**BEFORE THE HEARINGS PANEL
FOR PROPOSED PRIVATE PLAN CHANGE 31 TO THE WAIMAKARIRI
DISTRICT PLAN**

JOINT WITNESS STATEMENT

Topic: Groundwater and surface water issues and implications for stormwater management

TO PC31 Conferencing Experts FROM Eoghan O'Neill
DATE 17/08/2023
RE Proposed Private Land Plan Change Request 31 – Responses to WDC Comments

Attachment 1 - Long section_Example 1

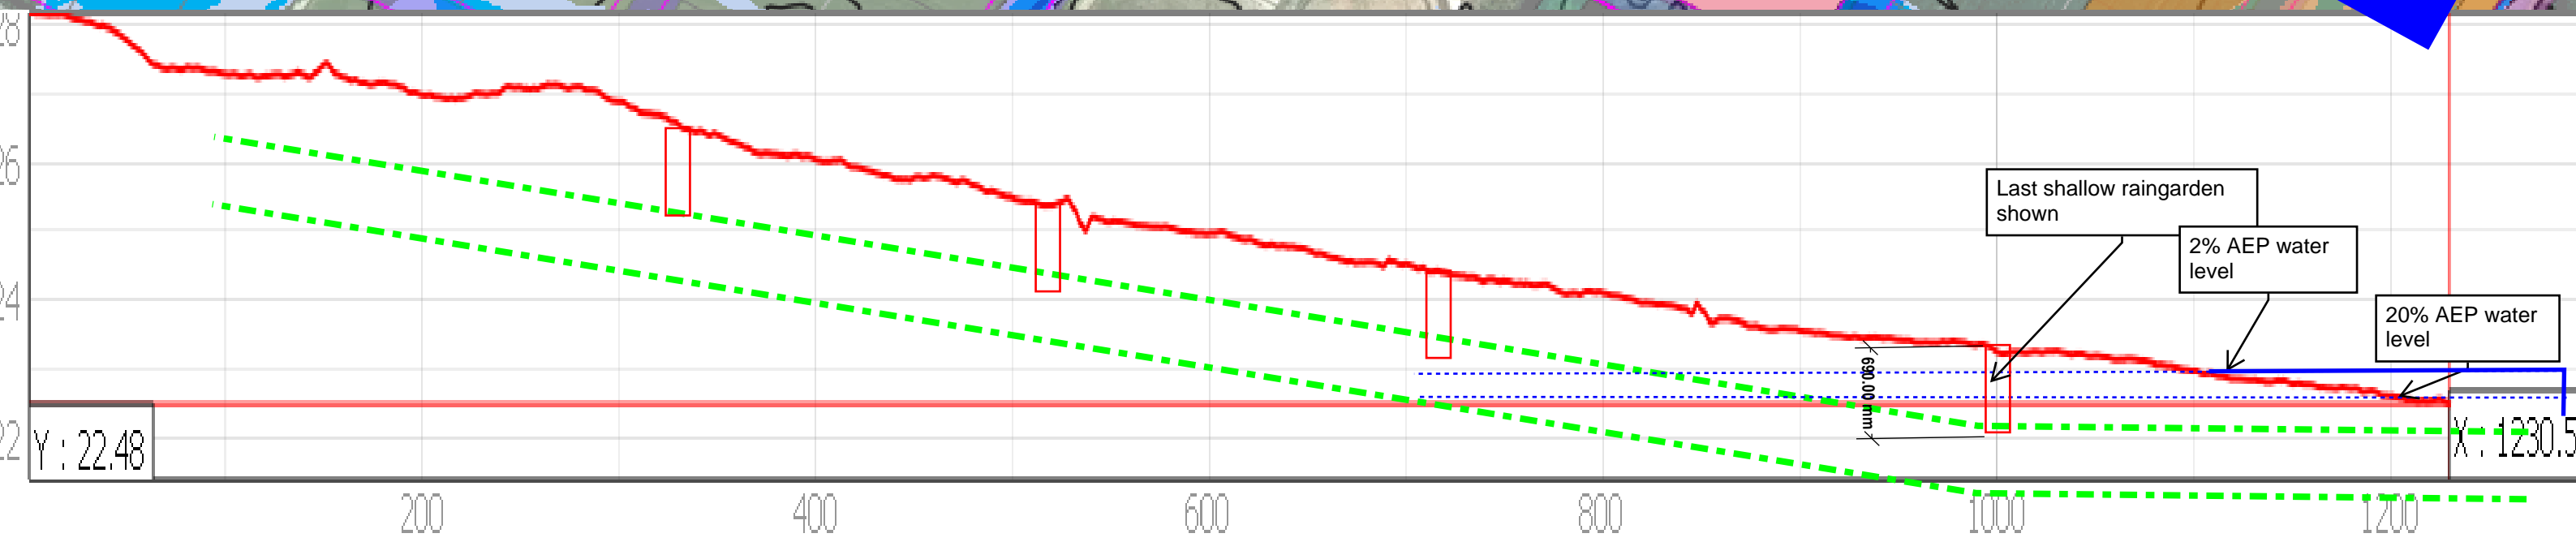
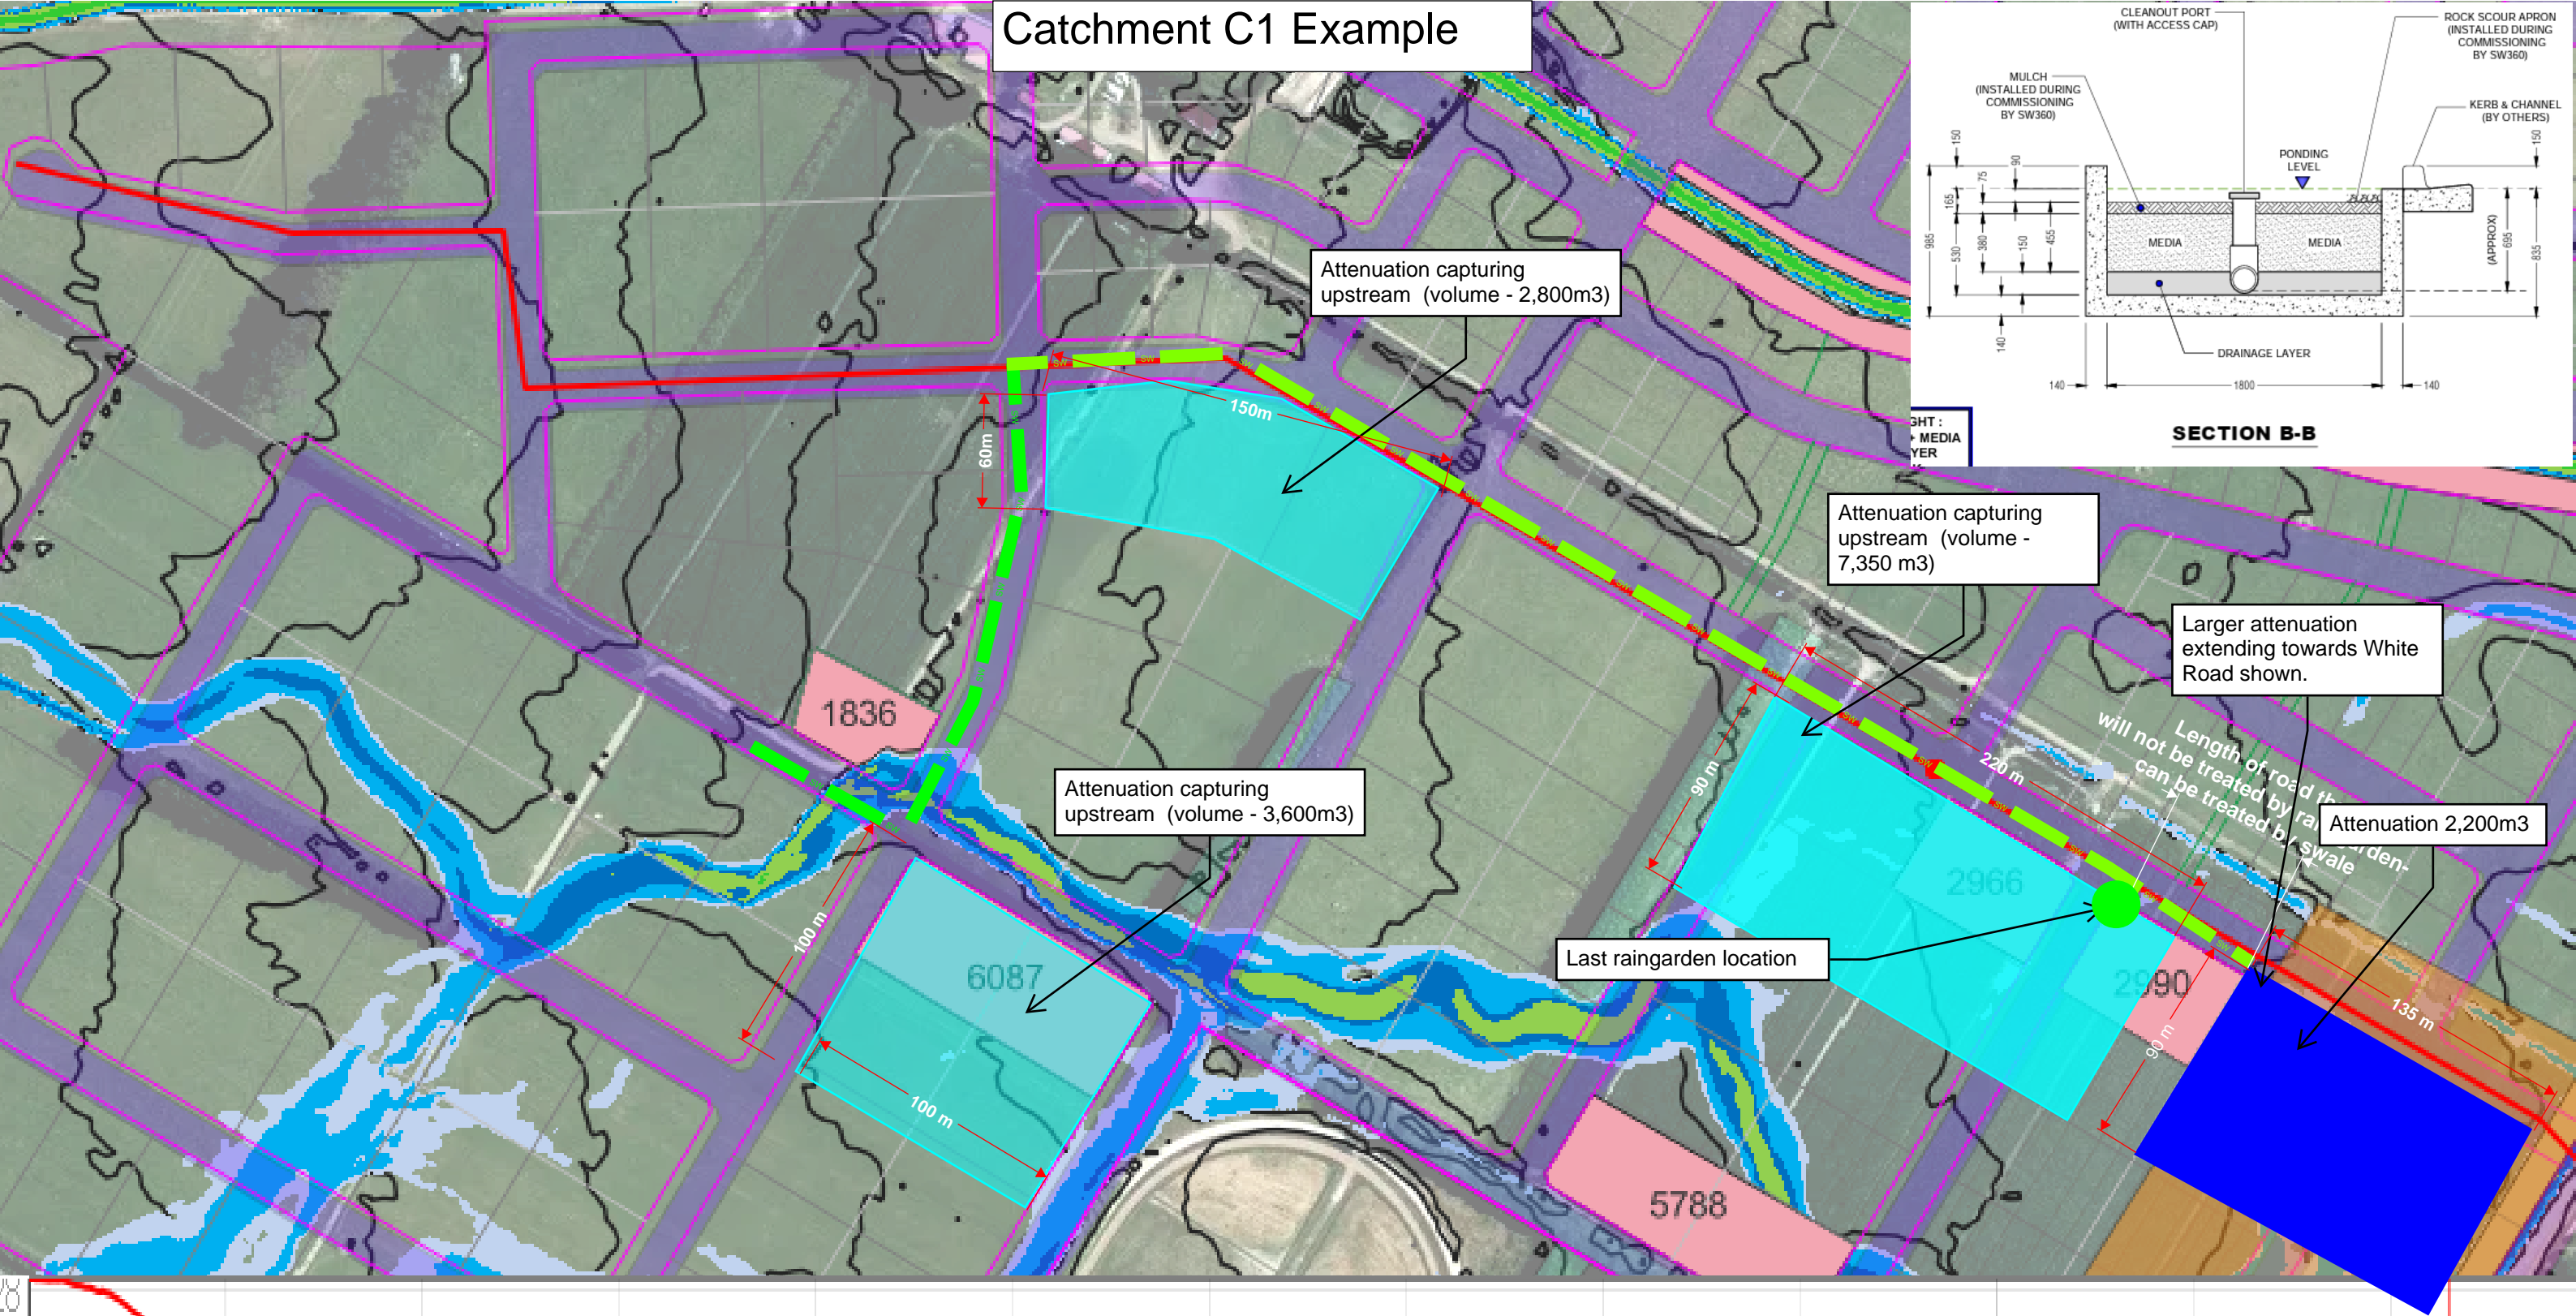
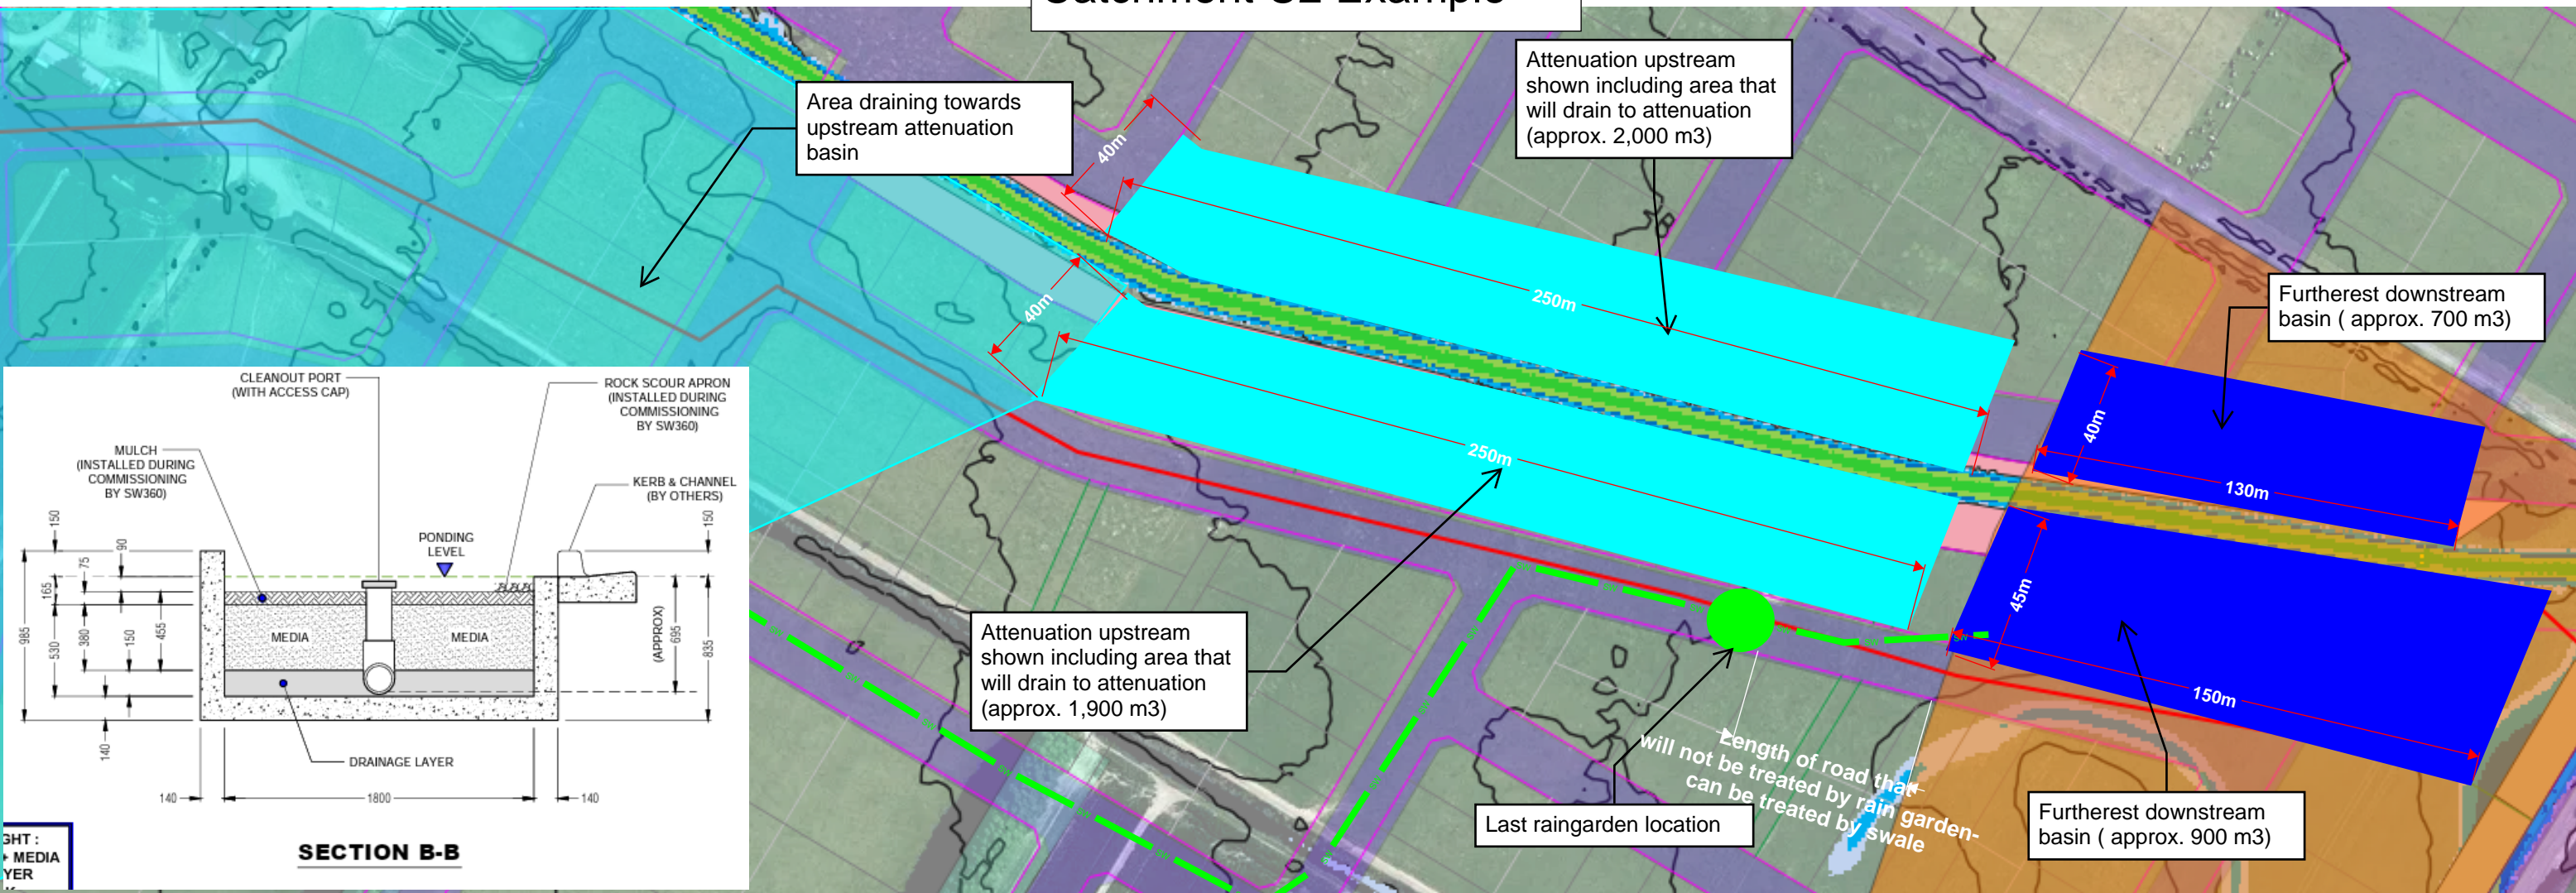
Paragraph 41, 42 & 43 – concerns were raised about areas of the development that will not be serviced by proposed basins and whether the basins are appropriately sized and located.

Approach to answer this was to consider the existing site contours, the proposed site (road) layout, and where flows would be reasonably expected to be able to divert towards the proposed basins. See **Attachment 1 and Attachment 2** which provide proof of concept long sections for the lower basins in Catchments C1 and C2.

The total area that can drain to basins is approx. 126.4 ha and the area which cannot drain to a basin is approx. 26.4 ha. The area that cannot feasibly drain towards the proposed basins is along Whites Road and the corridor width ranges from 150 m in the south to 220 m towards the north (Ohoka end). It should be noted that a significant proportion, approx. 10 Ha, of this 26.4 Ha will not be subject to increased impervious development due to the protection of key flow paths, the allowance for a large riparian strip along Whites Rd and the presence of stormwater detention basins. For the sake of conservatism, the full 26.4 Ha has been used as unattenuated area in this assessment.

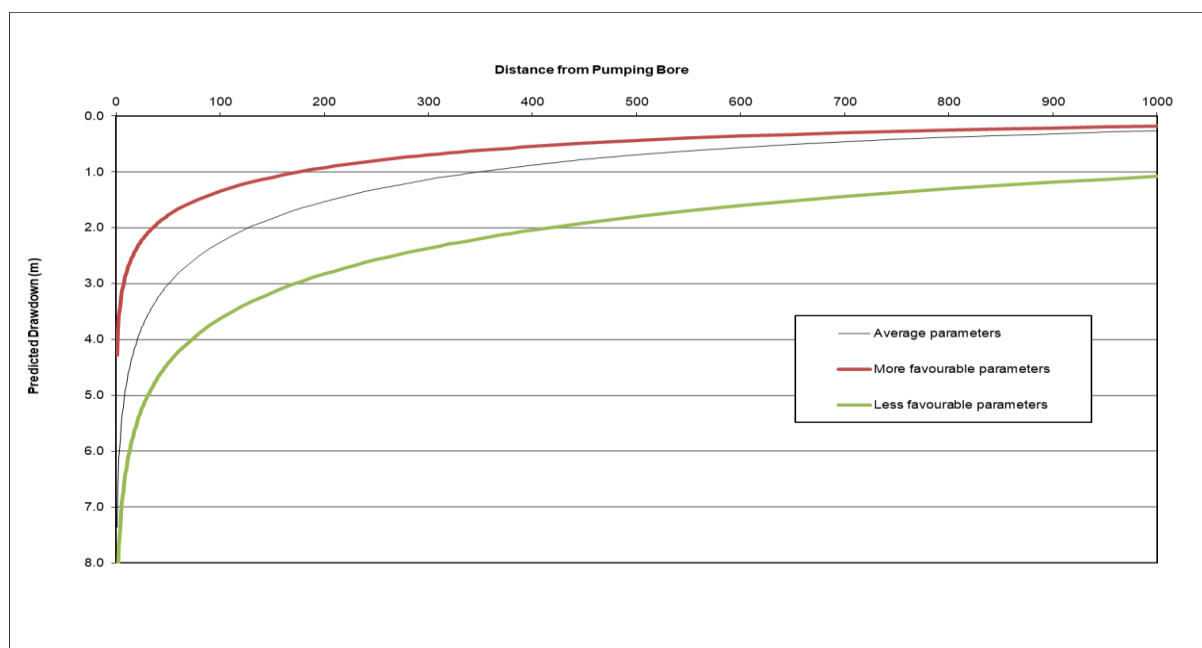
With regard to the preferred deep onsite water supply option, Mr Roxburgh had potential concerns regarding uncertainty in the number of bores that may be required, and how spaced out they may need to be if aquifer parameters proved be different (larger predicted drawdown effects) than the parameters used by PDP for preliminary well interference modelling. The specific concern of Mr Roxburgh is that if there is an excessive number of bores required, or they were excessively far apart, the supply may be uneconomic for the council to take over and operate.

Based on Mr Roxburgh's concerns, Mr Steffens has carried out further work to clarify these issues. The drawdown interference modelling described in Mr Steffens evidence was based on adopting the average aquifer parameters from previous constant rate pump testing (December 2015) in existing Ohoka deep supply bore BW24/0262. Based on those adopted values (in addition to more favourable and less favourable aquifer parameter scenarios), Mr Steffens has carried out further assessment to show the potential drawdown profile in the deep aquifer with distance from a single individual proposed pumping bore. The resulting figure is shown below and was presented at the meeting of the experts on 17/08/2023.

The drawdown profiles presented are based on abstraction from a single bore continuously at 9.3 L/s for a 150 day period. This rate represents a third of the proposed daily volume limit (2,412 m³/day, equivalent to continuous pumping for 24 hours at 27.9 L/s). Therefore, the full daily volume limit under this scenario would be provided by 3 bores as per the evidence previously presented by Mr Steffens at the hearing (with an additional bore required to be drilled for redundancy).

Therefore, if the average aquifer parameters adopted from the previous constant rate testing prove to be applicable, a potential average bore spacing of around 500 m is considered appropriate for a total of three supply bores, while ensuring no adverse operational drawdown interference effects in BX24/0262 (or the new supply bores).

If more favourable parameters (such as those indicated by the red profile shown in the figure) were to be derived during testing of the proposed bores, the effects would be less and therefore three supply bores would still be viable with similar or less spacing between bores.

The green profile line shown in the figure shows less favourable aquifer parameters. This level of effect is based on the most conservative representation of the results from the previous constant rate pump testing in BX24/0262. The total drawdown interference in BX24/0262 from three proposed bores operating under the same conditions as the previous assessment (same separation distances, rates and pumping duration) would be 5.4 m. This is a considerable amount of drawdown interference, however there would still be around 4 m of available drawdown remaining in BX24/0262 under this scenario during predicted summer groundwater level conditions (even considering the overly conservative pumping rates and duration adopted for the assessment). If testing of new bores showed this scale of interference, then consideration could be given to additional supply bores and/or spacing to manage the potential effects.
